Case Reference:
ACP 324155

Observation by
Cahermurphy Area
Community Group
in response to
Cahermurphy Renewables
DAC Application
ACP-324155

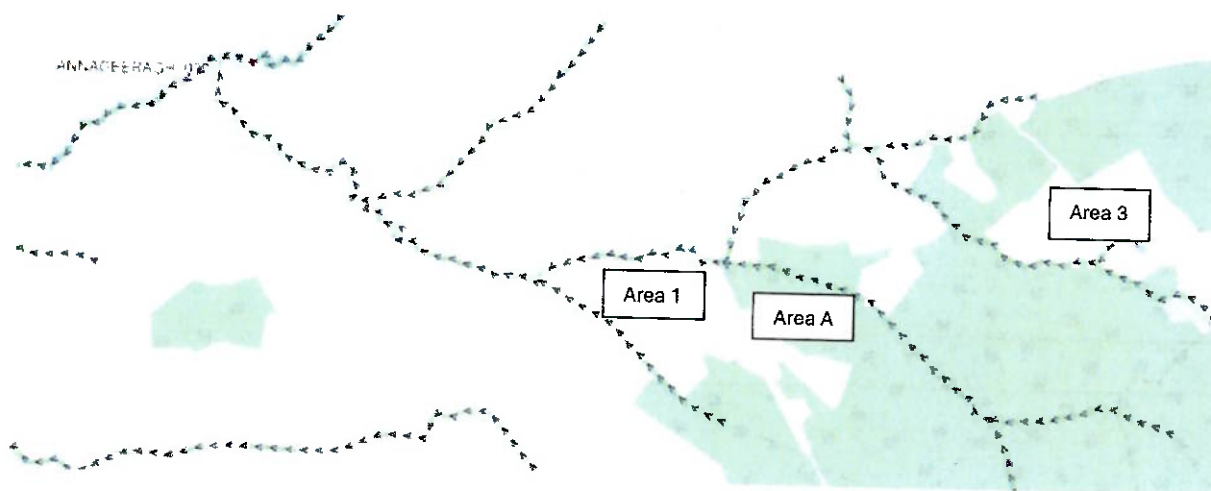
Continuing with issues regarding quantities set out in the EIAR we are left in a quandary regarding the peat placement within clear fell areas around turbines. We are told in this chapter that it will be '*Up to 1m in height*' but in Appendix 4-3 Peat and Spoil Management Plan we are told '*1.2m in height across specific areas*'. This is yet another serious discrepancy giving us due cause for concern.

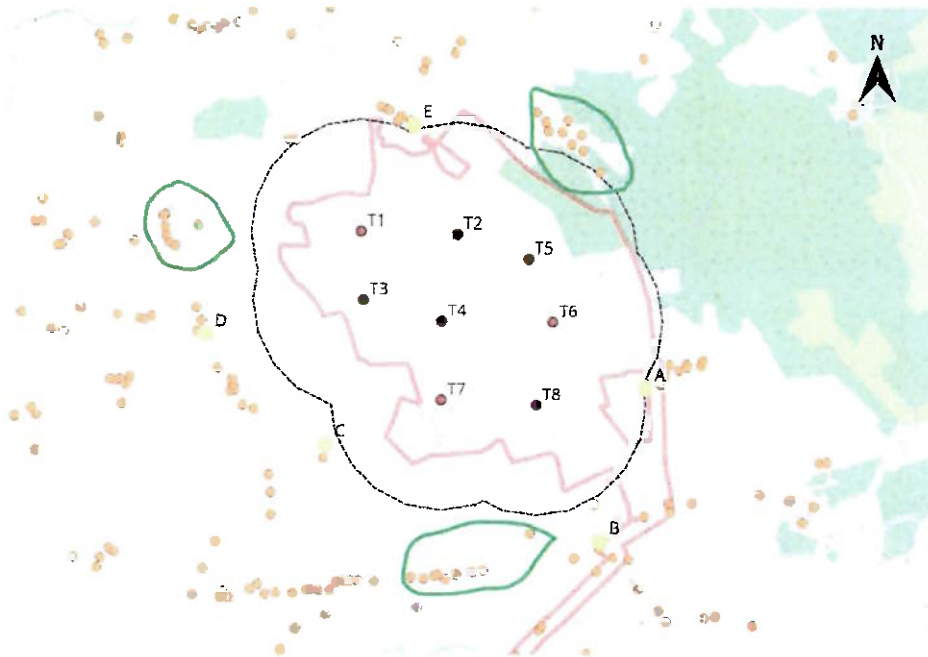
We have already made our views on audible and inaudible sound, and the effects they might have, clear when we discussed the issue under Chapter 5, Population and Human Health and will not repeat them here. We find it encouraging in the section on the fundamentals of acoustics that the developer has acknowledge the existence of sound outside the audible range and makes it clear that the dBA weighting has been developed solely to measure audible sound.

When considering the study area for assessing the potential noise impact we are referred to Appendix 12-2, where a list of operational, awaiting planning and pre-planning wind farms are given. Once again, we must make the point that several, including some currently in the planning system, seem to have been omitted. These include Illaunbaun Wind Farm (currently at ACP), Slievenalicka Locally-owned Turbine (currently at Clare County Council), Dehomad (pre-planning) and Crag (pre-planning).

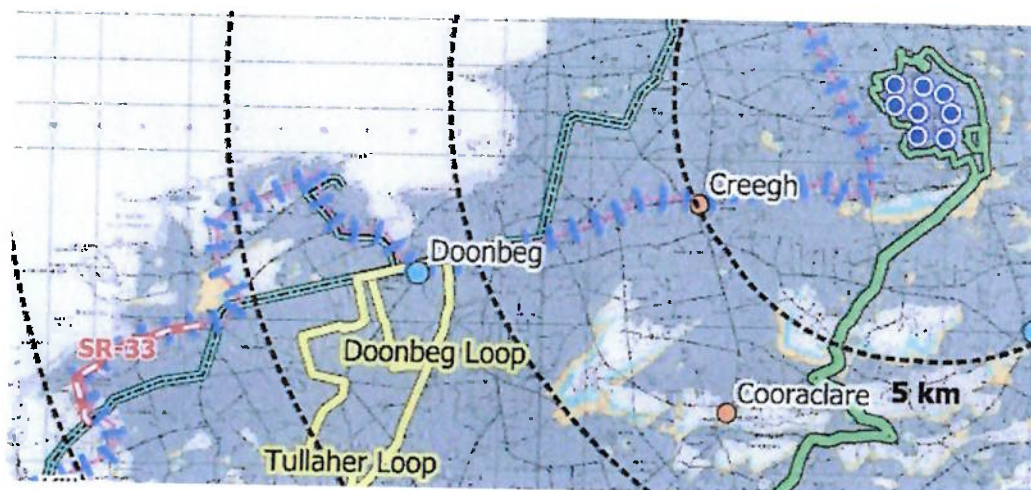
In terms of height we cannot agree that such industrial turbines would appear appropriately scaled within the surrounding landscape. We believe that, in conjunction with the differing heights and the various rotor blade dimensions and rotational speeds involved in the existing Cahermurphy Wind Farm, the turbines proposed would add further confusion to an already complex skyline from all directions.

We note that three LCAs are scoped out of the assessment and this is of particular concern as the proposed grid connection route runs through the Shannon Estuary Farmlands, one of those scoped out.
